Location Name: Waag North NENW Pad 1 Location ID 439195

COLORADO
Energy & Carbon Management
Commission
Department of Natural Resources

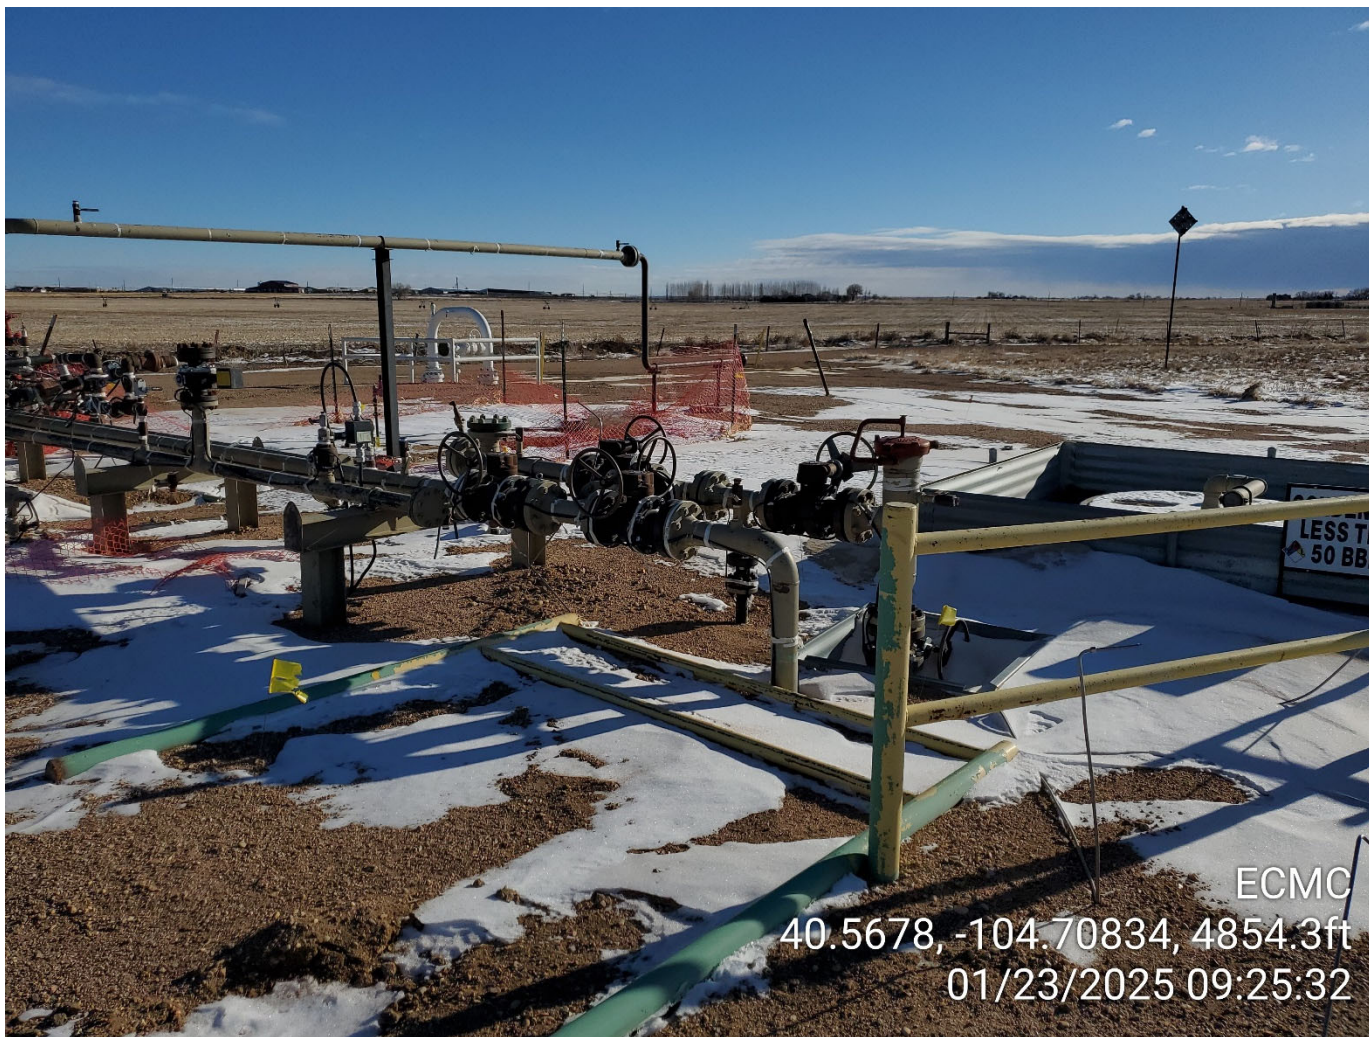
Buried condensate vessel requires assessment with soil samples for laboratory analysis of Table 915-1 Contaminants of Concern.
